CCC Member Hanson Bass Point

In this submission I am objecting to the proposed amendment on the basis that the importing of VENM/ENM will create an unwanted dust impact and the construction of the visual amenities will have a minimal benefit to blocking off quarry activities for the wider community.

A further reason for my objection is because the Modification document (Bass Point Quarry Modification 3 PA 08_0143) which is open for public comment does not clearly show where visual amenity construction will occur, other relevant details (location/volume/quantity) regarding the materials to be imported to the quarry are missing from the main document.

Showing 4 - Visual Amenities to be constructed

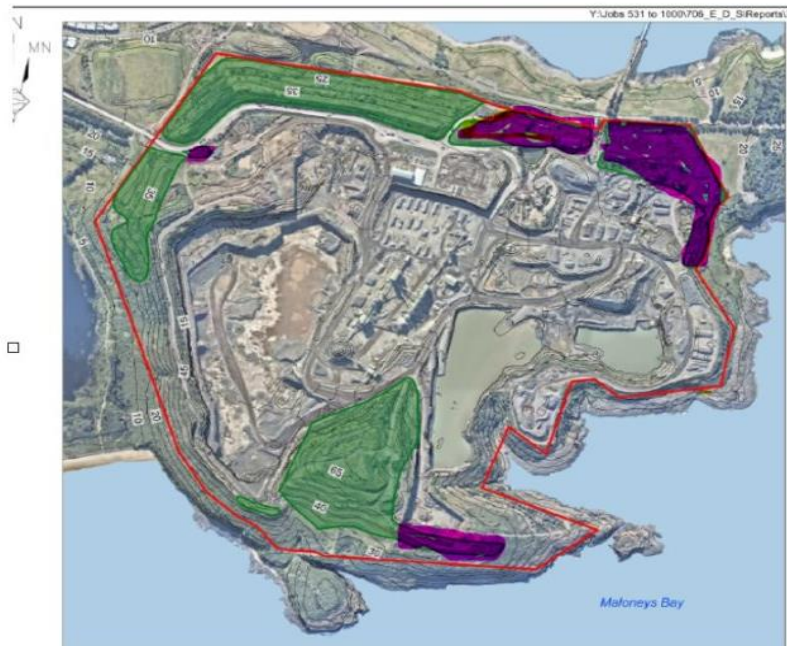
1. The visual amenities to be modified or constructed are not clearly detailed in the modification proposal. I am requesting the approval document to be revised to include a diagram that clearly shows existing visual amenities vs the proposed visual amenities, the diagram needs to allow the general public to understand the locations where the visual amenities will be constructed or modified. Refer to the attached diagram as an example to clearly show the proposed work of the visual amenities to be constructed.
